TO: DEVELOPMENT REVIEW BOARD **DATE:** 11/18/99
FROM: PROJECT COORDINATION
SUBJECT: CASE 92-DR-99

REQUEST: Approve Site Plan & Elevations for a Commercial Center
PROJECT NAME: McDowell Mountain Ranch Center
LOCATION: SWC McDowell Mountain Ranch Road & 105th Street

PRELIMINARY SITE PLAN
SCALE: 1" = 60' - 0"

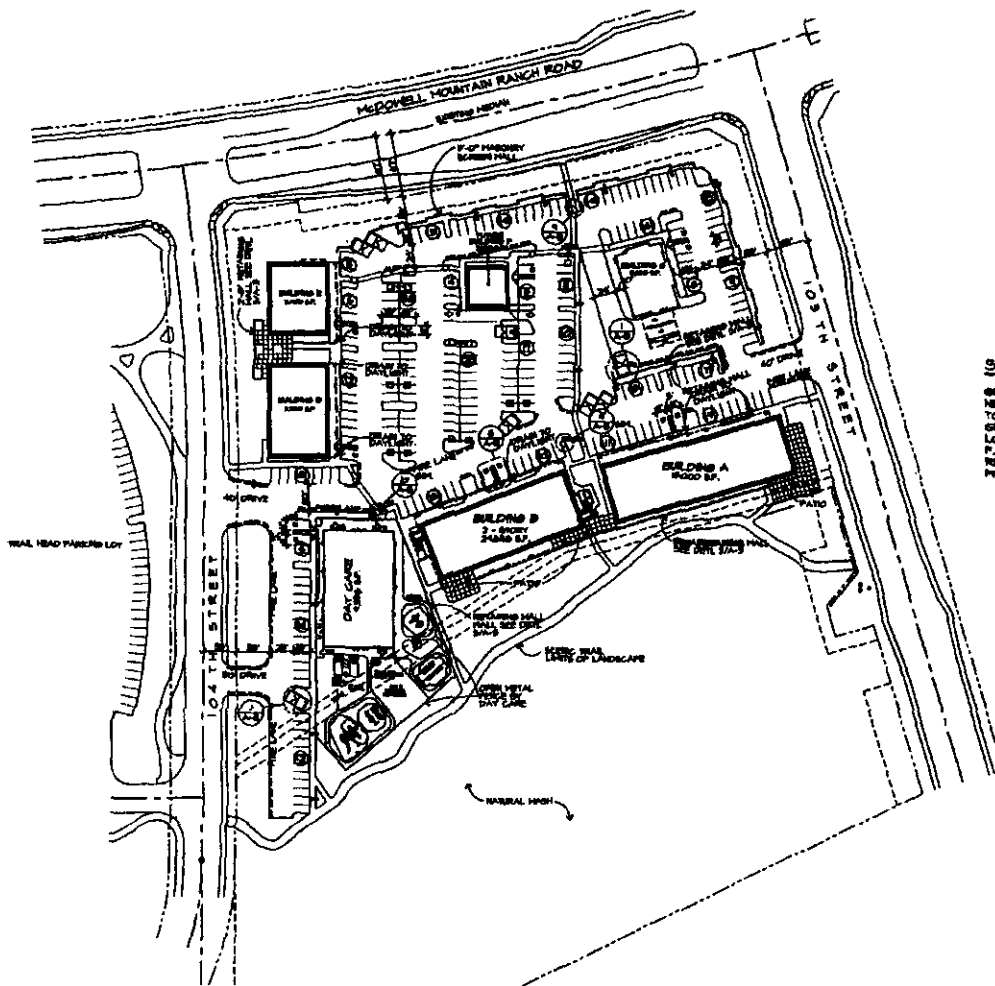
- ✓ 5. *Prior to final plan approval, revise site plan worksheet graphic and calculations, to the satisfaction of City staff, to display the revisions to the site plan including but not limited to the revised driveway locations.* *etc. approved 1/25/00 Jay*

DEAD-END PARKING AISLE DETAIL

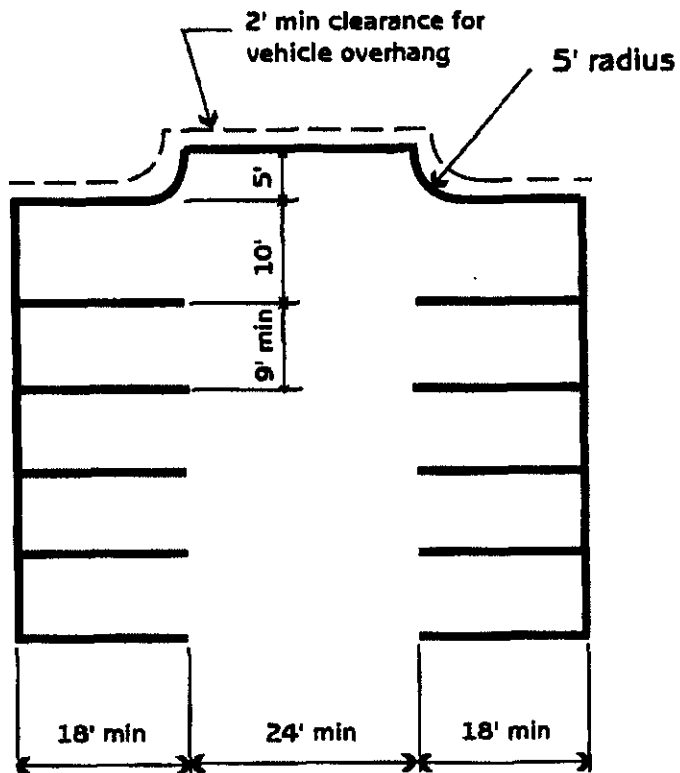
1. *The minimum internal parking aisle width shall be 24 feet.*
2. *The main access drive through the site (connecting 104th Street to 105th Street) shall be a minimum width of 30 feet.*
3. *There shall be a minimum queuing distance of 120 feet provided for the proposed bank drive-thru, measured from the drive-thru entrance to the service window area.*
4. *The dead-end parking aisle shall be designed in conformance with the attached detail.*
